Access Compliance Report

Public Rights-of-Way

(Curb Ramps)

Intersection ID: 48987	Main Street: ASHTON_GATE_DR	Cross Street: SMITHFIELD_DR	Location:	NE
ADA ID: F67D86D5D619	Ramp Type: BlendTrans2	Initial Pass/Fail: Pass	Overall Compliance: No	Severity Score: 2.5
Codes/Mitigation Info/Possible Solution		Field Measurements/Component Compliance

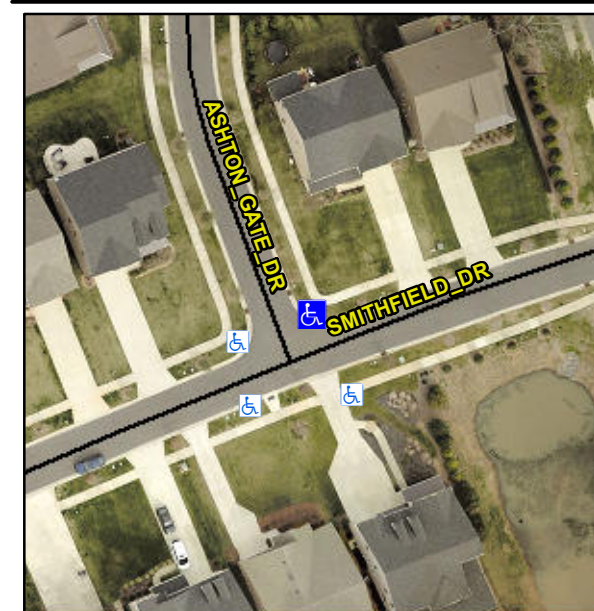
Remove & Replace Detectable Warning System.

R305.1.4
